## **CABINET MEMBER FOR ENVIRONMENT – 26 MARCH 2020**

### **OXFORD – B4495 WINDMILL ROAD– PROPOSED EXTENSION OF 20MPH SPEED LIMIT**

**Report by Director of Community Operations**

Background papers: Plan of proposed speed limit and Consultation responses

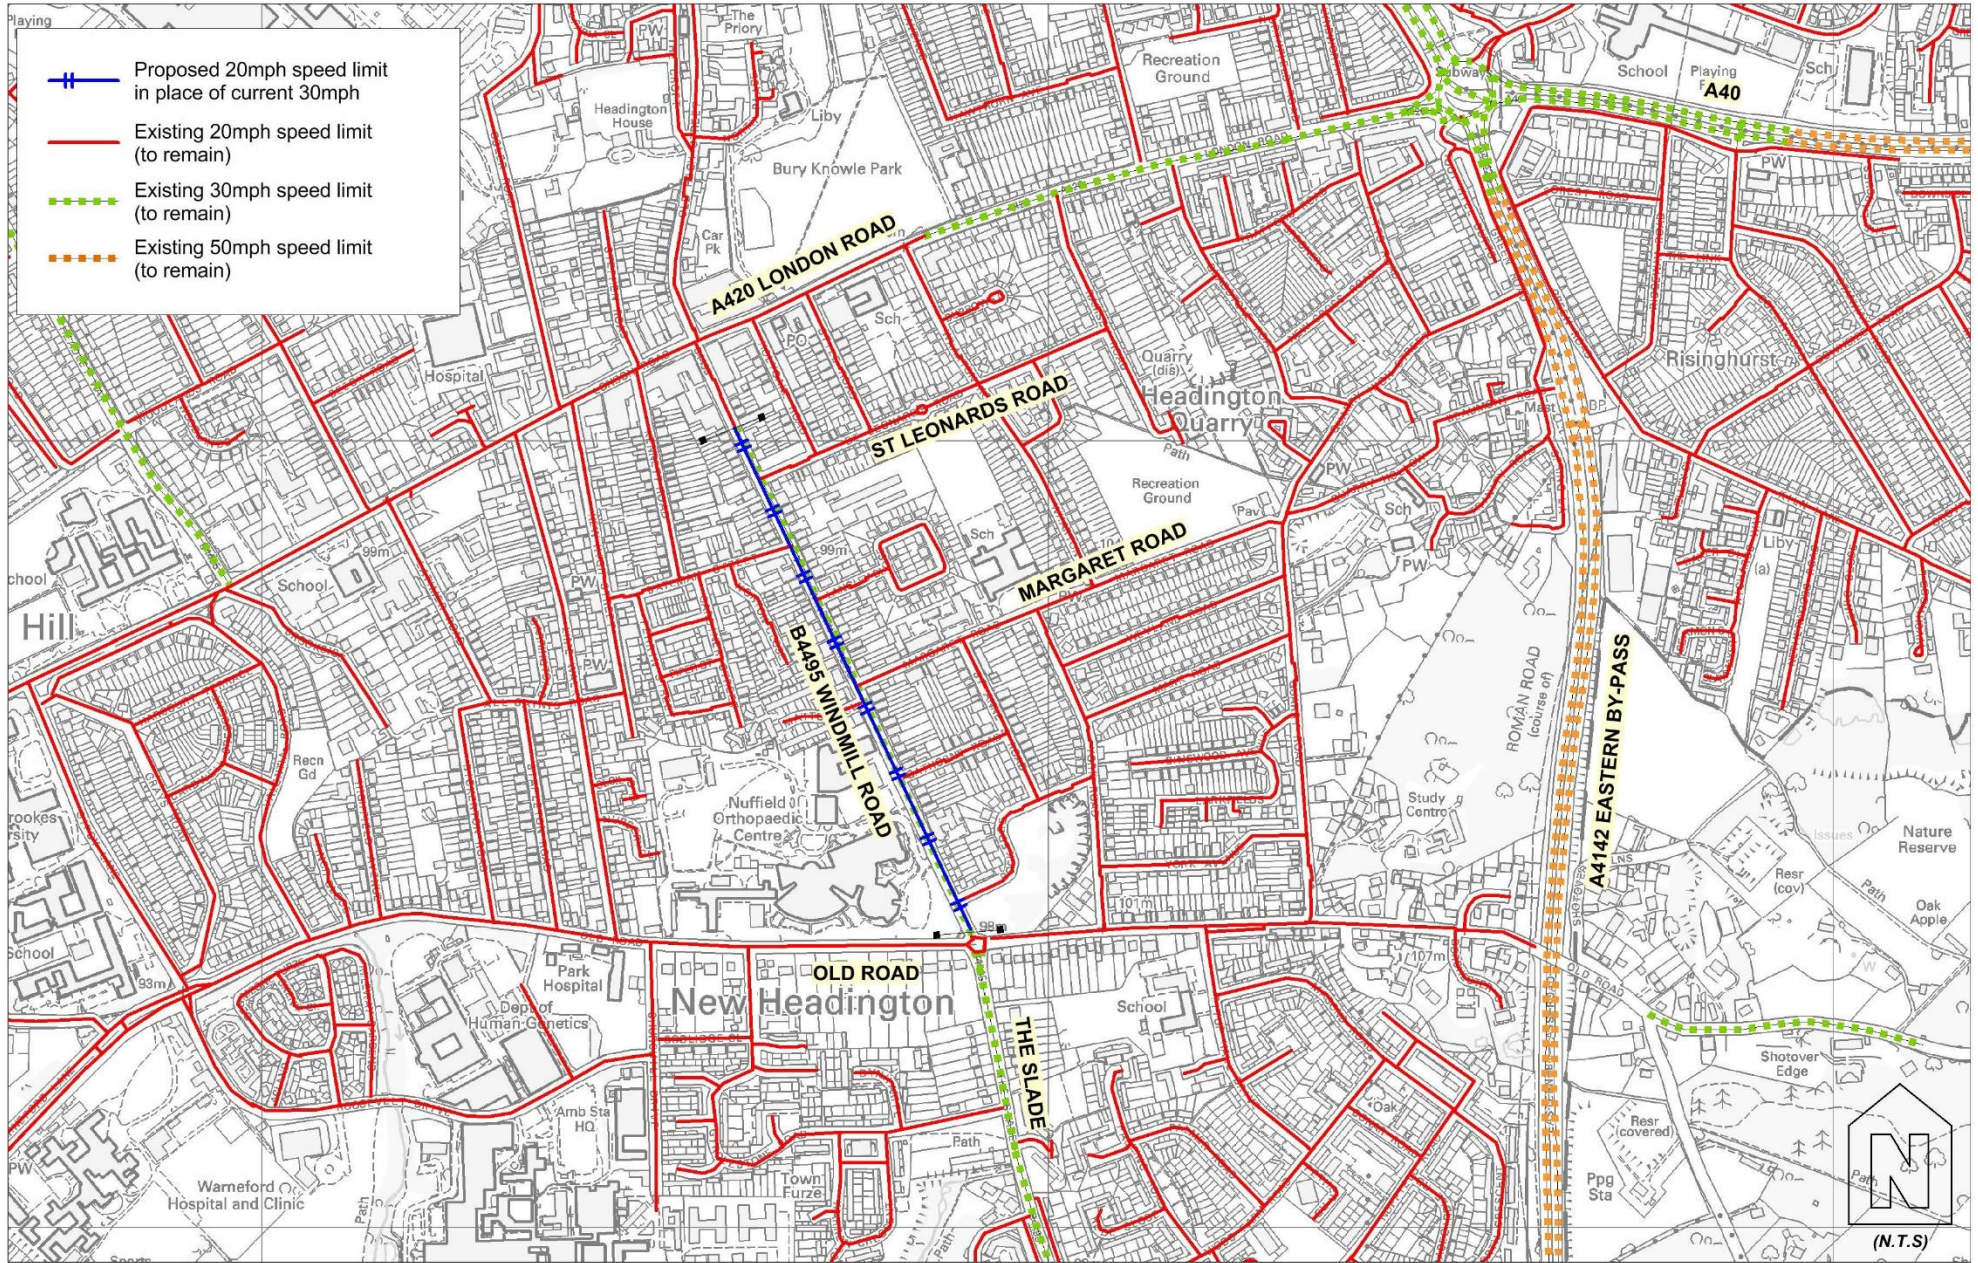
6. Thames Valley Police objected to the proposals on the grounds that current measured speeds on the relevant part of Windmill Road are above the threshold (24mph) indicated by national guidelines issued by the Department for Transport for setting 20mph speed limits without supporting traffic calming measures.

7. A response from the Oxford City Council traffic team suggested that a very minor extension of the speed limit to include the signalled crossroads with Old Road would be helpful, noting that a 20mph speed limit already applied on both arms of Old Road and the suggested amendment would simplify the signing of the speed limits here.

(2) Oxford City Council Traffic Officer	<p><b>Concerns</b> – It seems that the current proposal might end up being more confusing if the signs are positioned where Steve indicated that they might be placed.</p> <p>Wanted to put forward the suggestion that the entire junction, plus the top end section of the Slade would be 20mph. This would mean simply two set of signs (either side of the Slade) prior to the junction.</p> <p>There have been issues with drivers as they exit old road, see the 30mph sign, and miss the 20mph sign on the other side of the junction.</p>

1. The Cabinet Member for the Environment is RECOMMENDED to approve the proposals as advertised but to include also the adjacent signalled junction of Windmill Road with The Slade and Old Road.

10. While accepting the concerns of Thames Valley Police that the current average speeds fall slightly outside the threshold cited in national guidance for a 20mph speed limit not supported by traffic calming measures, the overall balance of the responses is clearly supportive.
